ORDINANCE NO. 2013-056

AN ORDINANCE GRANTING CERTAIN APPROVALS FOR THE SPRINGS OF VERNON HILLS GENERALLY LOCATED ON THE WEST SIDE OF MILWAUKEE AVENUE AT THE INTERSECTIONS OF NORTH AND SOUTH WOODBINE CIRCLE IN THE VILLAGE OF VERNON HILLS, LAKE COUNTY

Department of Community Development  
**TECHNICAL REVIEW COMMENTS #2**  
**FOR**  
**SPRINGS OF VERNON HILLS**  
**October 25, 2013**

SUBJECT: MONUMENT SIGN

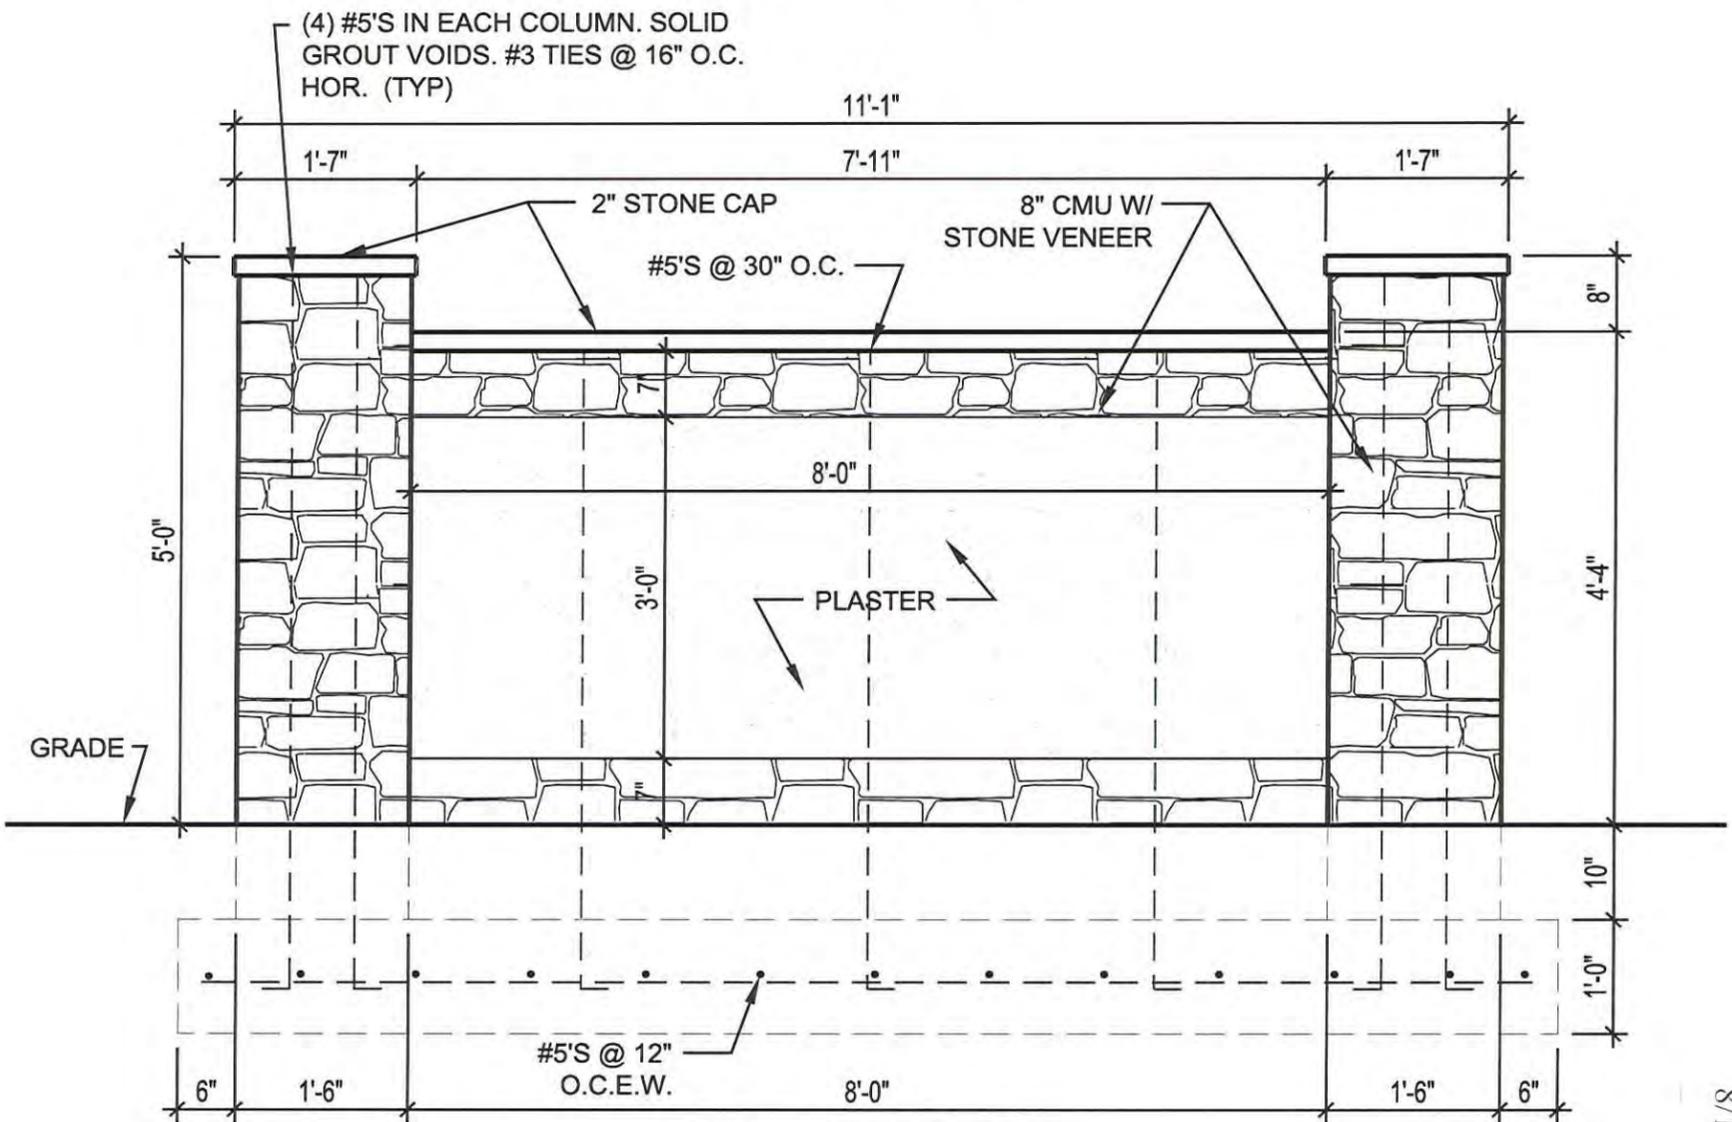
6. Provide details for the Monuments, will they be lighted?  
*Monument sign details have been provided. The monuments will be externally illuminated in accordance with the Village of Vernon Hills ordinances.*
